**The City of New York**  
**Community Board 8 Manhattan**  
*Parks and Waterfront Committee*  
*Thursday, November 13, 2025 - 6:30PM*  
*Conducted remotely on Zoom.*

**MINUTES**

**Item 1: Description and Presentation of the revised plan for the reconstruction of 24 Sycamores Park, which was approved by Community Board 8.**

**The revised 24 Sycamores Park plan below was presented at the previous Full Board meeting on October 22nd and at the recent Parks and Waterfront Committee meeting.**

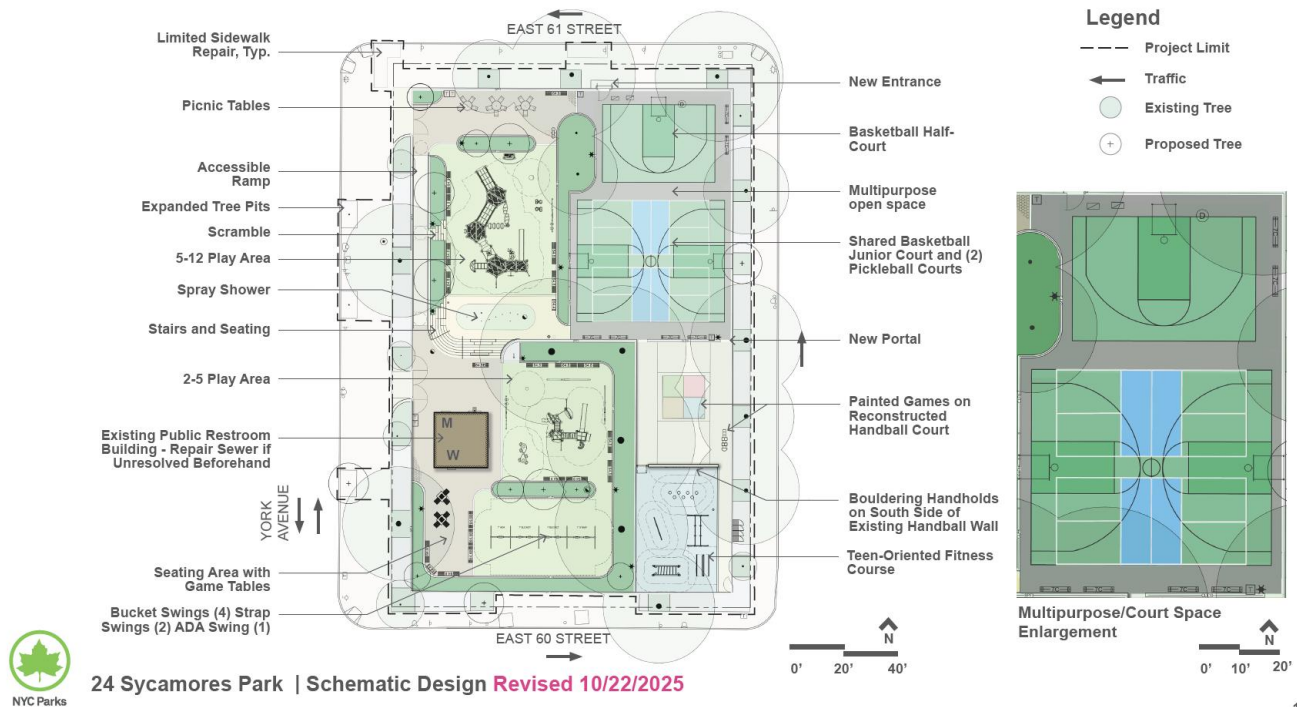
Two additional bucket swings for toddlers have been added, bringing the total to four. The design also retains two strap swings and one ADA swing, for a total of seven swings (an increase from the existing four). To accommodate these changes and maintain circulation around the restroom building, swing height has been reduced from 8' to 7'.

The adjacent seating area has been reduced in size but still provides a sheltered space for birthdays, seniors, board games, and similar activities.

Basketball court sidelines have been realigned to match the pickleball court sidelines to simplify linework and improve usability. This adjustment also creates a wider arc for basketball players to practice full-length 3-point shots.

Court lines for each sport are now shown in distinct colors to improve clarity. Parks will continue to study optimal color selection to address intersections and overlaps. The basketball “key” and pickleball “kitchen” are now differentiated with contrasting colors as well.

Parks evaluated reorienting the pickleball courts north–south but found it unworkable due to the required 8’ clearance behind baselines. A north–south layout would force players into fences on the basketball half-court and require taking additional space from the 5–12 play area to avoid basketball hoops obstructing lob shots. The courts will therefore remain oriented east–west to avoid injuries.

Steel tree pit guards along York Avenue have been removed from the plan to help offset rising costs. Parks found no evidence of vehicles striking the trees, likely due to existing signage, poles, and the substantial curb. Tree pit expansions to support tree health remain in the design.

The swing reconfiguration requires relocating one tree, which will now be positioned to provide improved shade for the 2–5 play area. There will still be 24 Sycamore Trees when the plan is complete.

Light pole locations have been adjusted based on the New York City Department of Environmental Protection (DEP) guidance regarding proximity to underground assets and further refined for safety and lighting coverage. These placements remain preliminary pending engineering review.
